STATE OF WASHINGTON
DEPARTMENT OF ECOLOGY

May 28, 2020

Re: Opinion pursuant to WAC 173-340-515(5) on Remedial Action for the following Hazardous Waste Site:

- **Site Name:** Rainier Mall
- **Site Address:** 4208 Rainier Avenue South, Seattle, WA 98118
- **Facility/Site No.:** 88987973
- **Cleanup Site ID:** 4187
- **VCP Project No.:** NW3261

Figure 5: cVOC groundwater data. Data presented includes groundwater samples collected between June 2000 and March 2020. From Urban Environmental Partners LLC (March 2020).

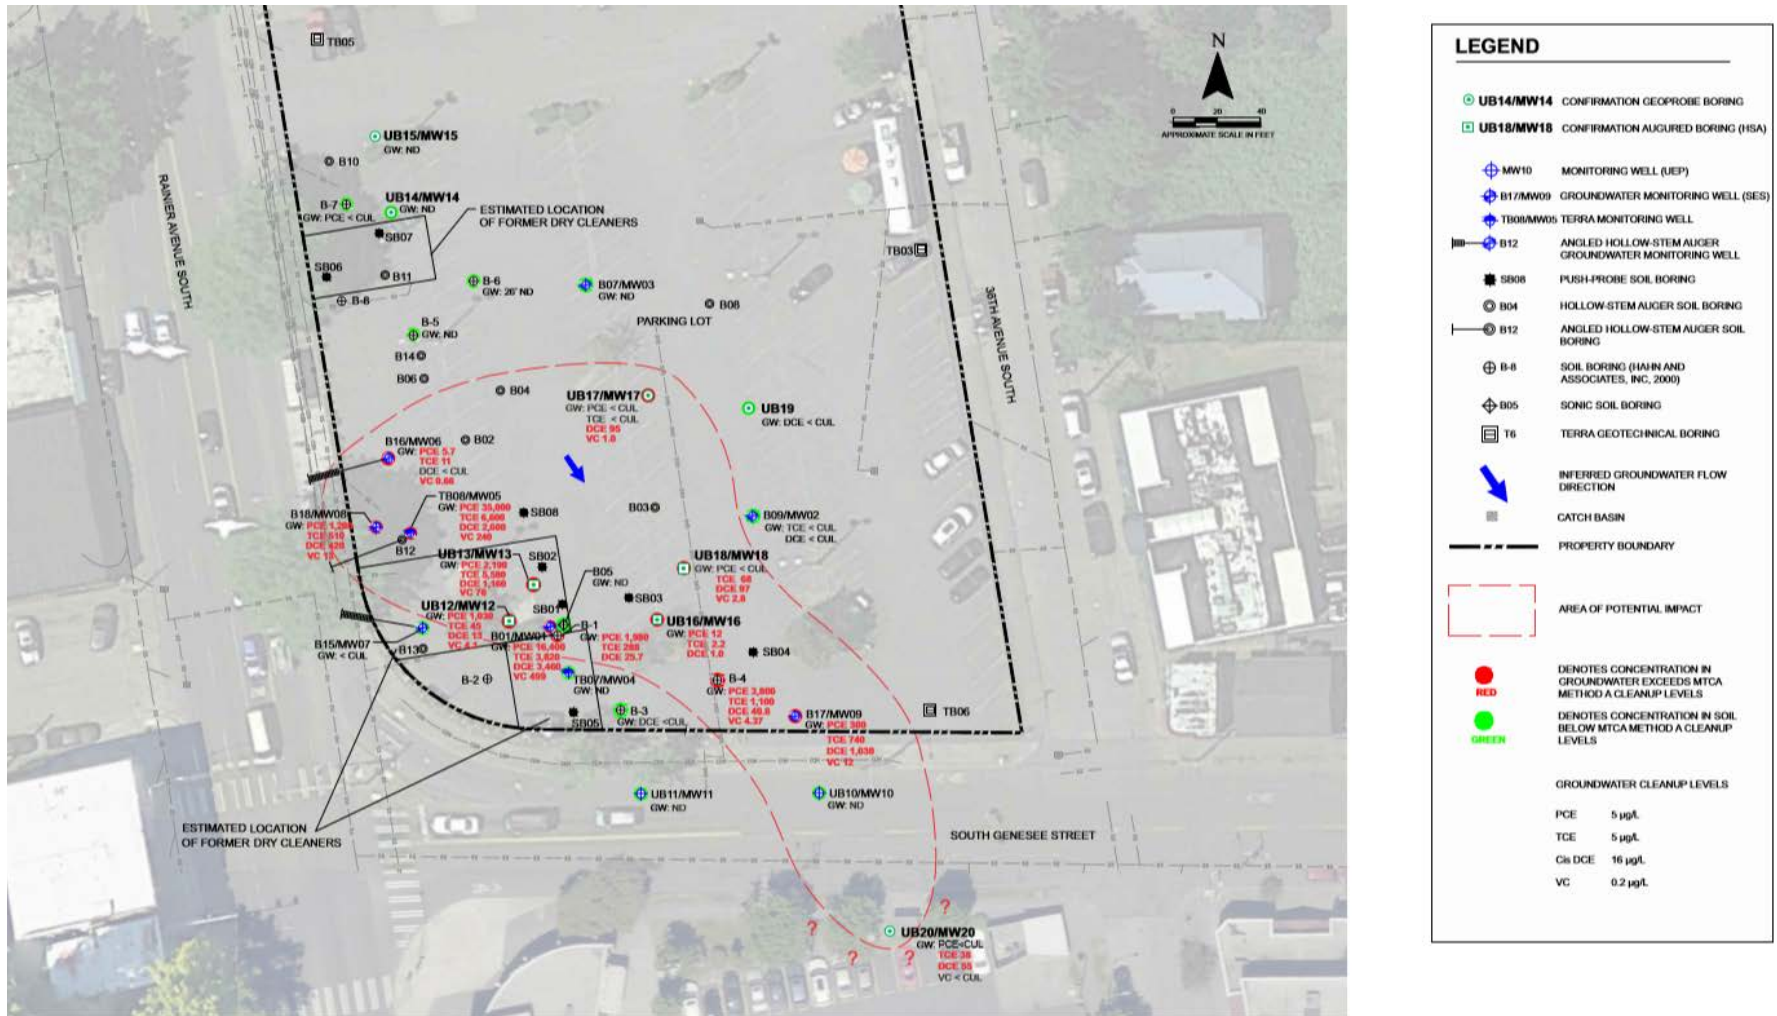
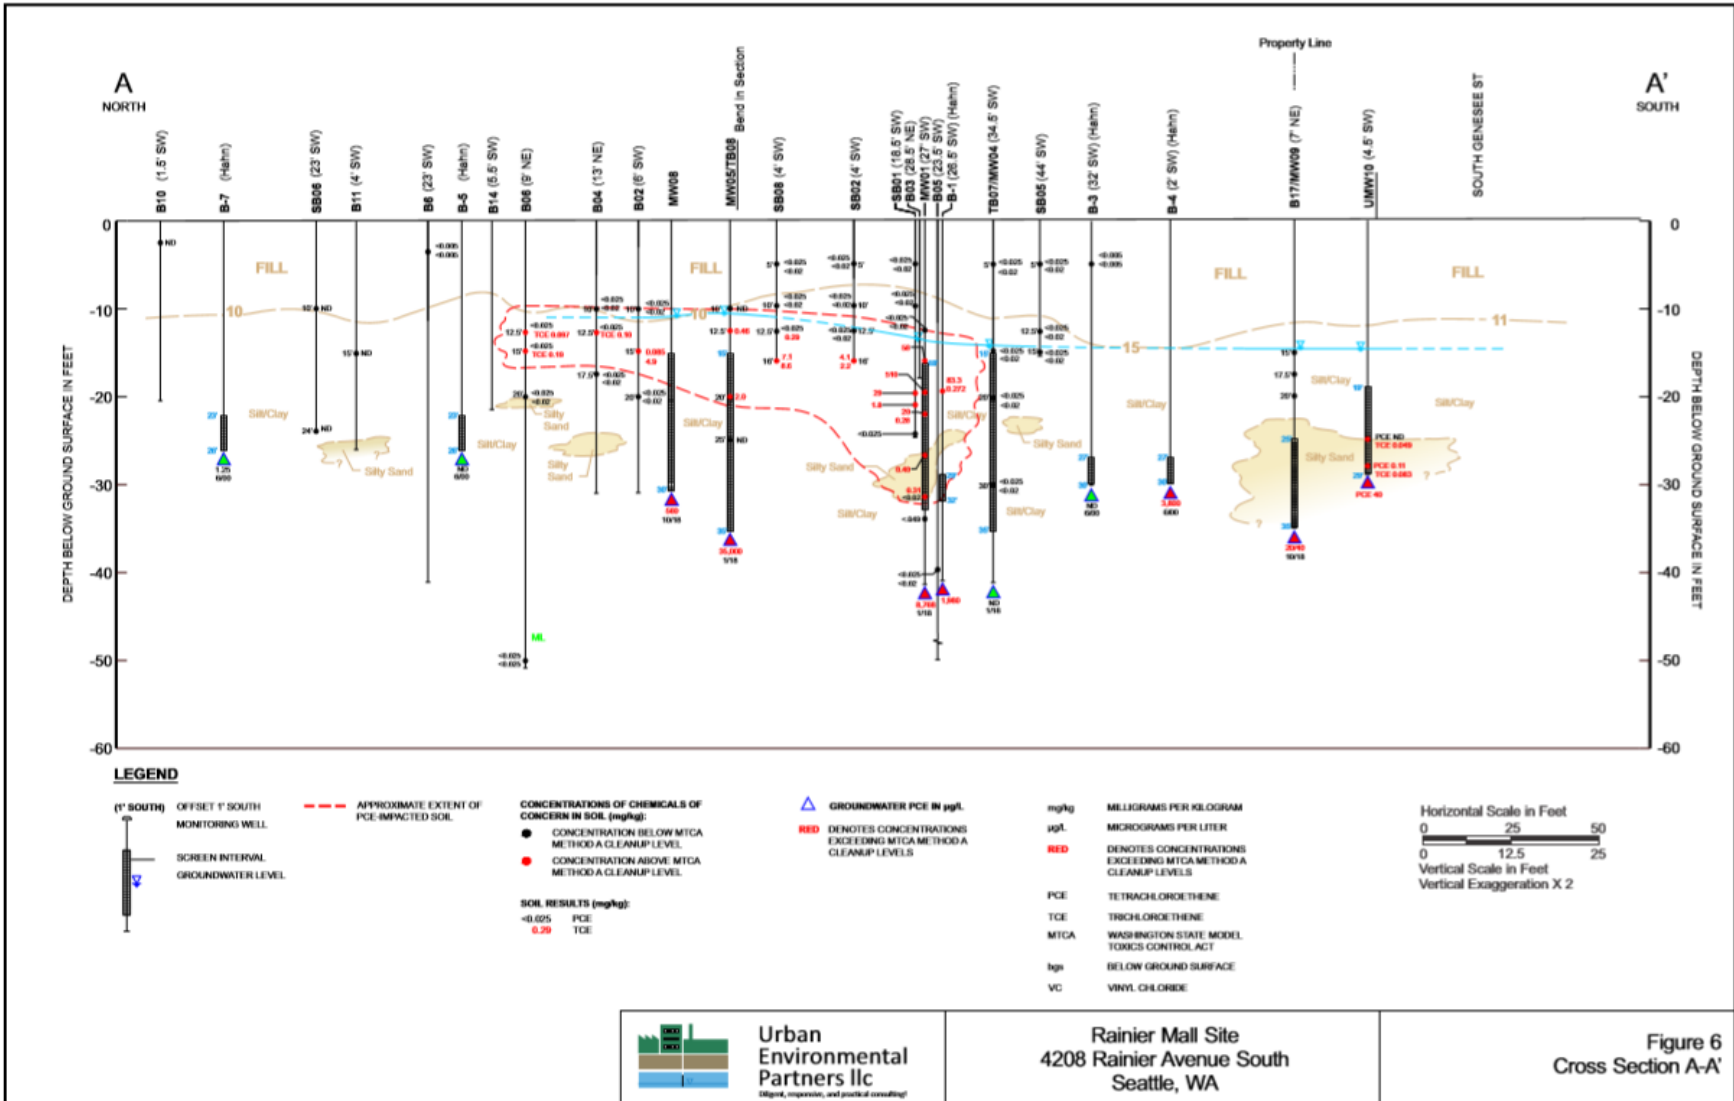
- The ground water elevation contour map developed from ground water elevations on April 16, 2019 (Figure 5 of the *Work Plan*) includes an elevation of 32.97 feet in MW02, which is not consistent with the contours. Please recheck this data point and revise the map, as appropriate. Also, please include data tables with well screen depths and elevations, ground water levels, and ground water elevations for all monitoring wells.

Figure 7
Cross Section B-B'

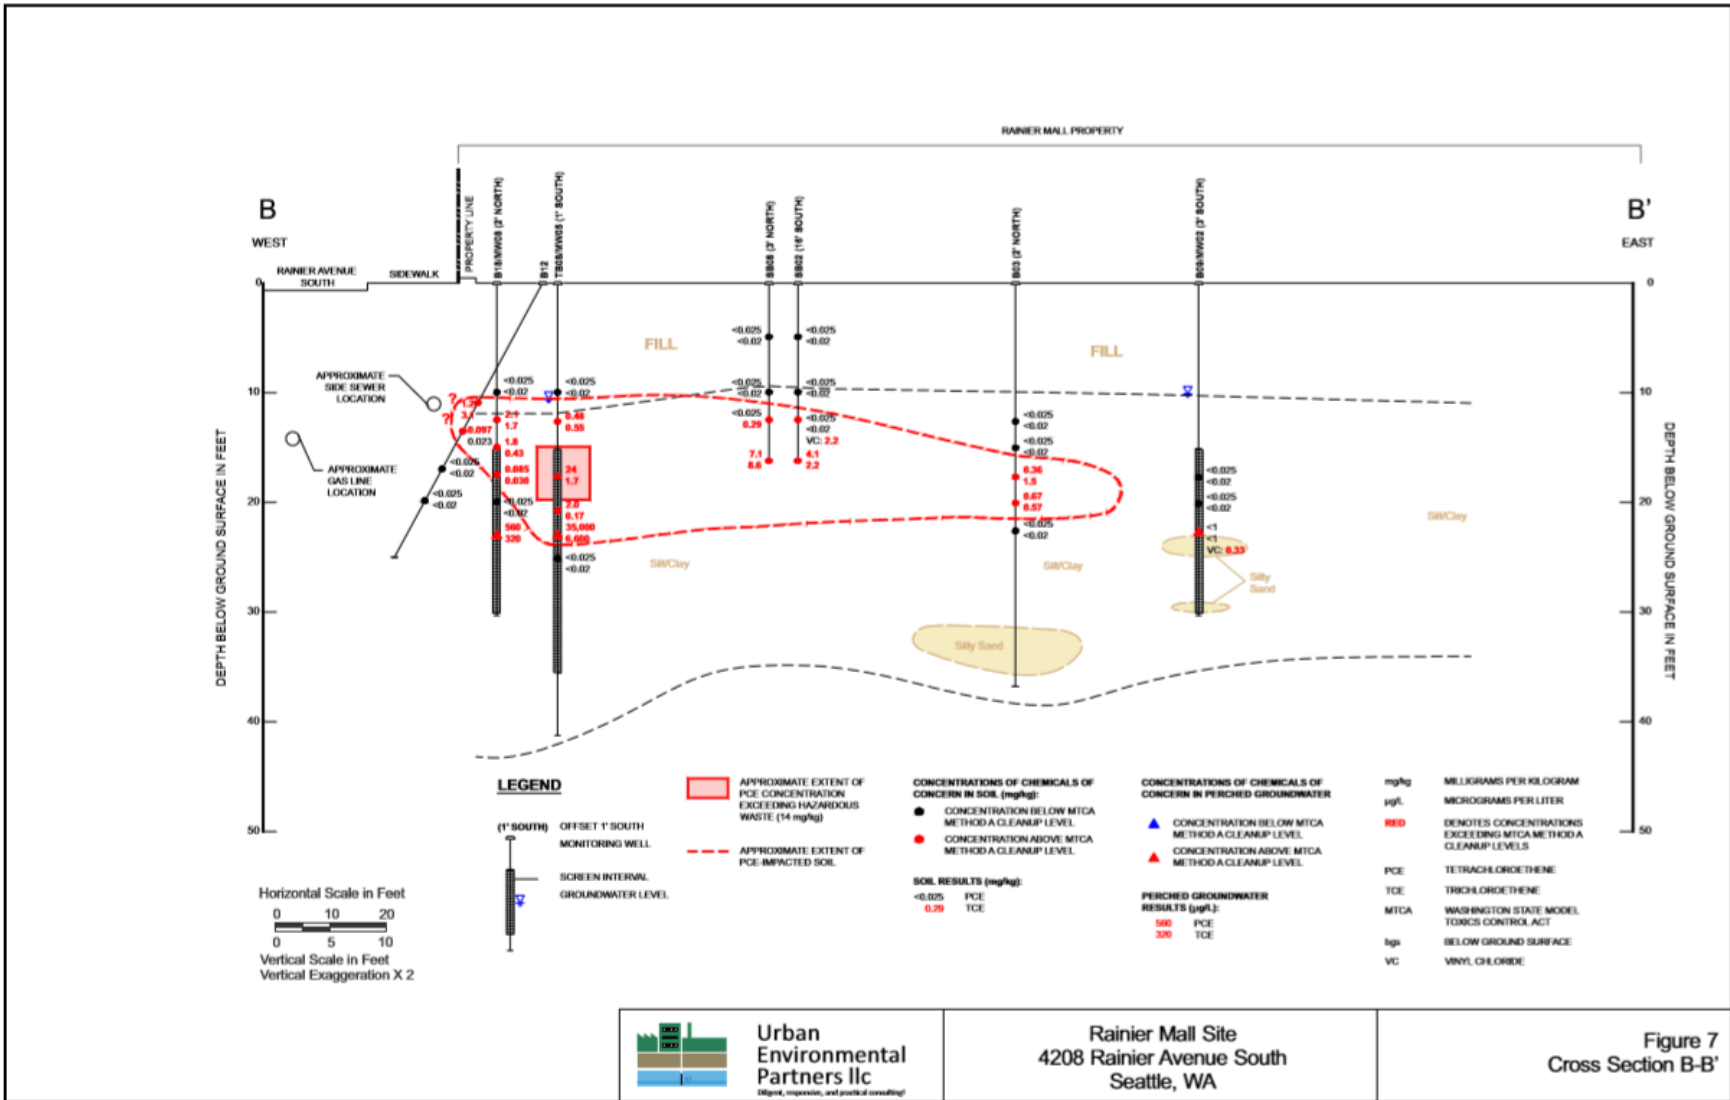
- Ecology requests the following revisions to the hydrogeologic cross sections in the *Work Plan* (Figures 6 and 7):
 - Figures 6, 7, and all future cross sections

- The vertical scale on all cross sections should be elevation relative to mean sea level (NAVD88), rather than depth below ground surface.
 - Show ground water levels and dates for any temporary and permanent wells shown on the sections.

- Show the elevations at which ground water samples were collected.
 - Include the total depth and stratigraphy for deep boring B05, which was drilled to a depth of 90 feet bgs.

- Cross Section B-B' (Figure 7)
 - Use of the term “perched groundwater results” is premature until the CSM determines if the uppermost zone of saturation is a perched ground water condition.
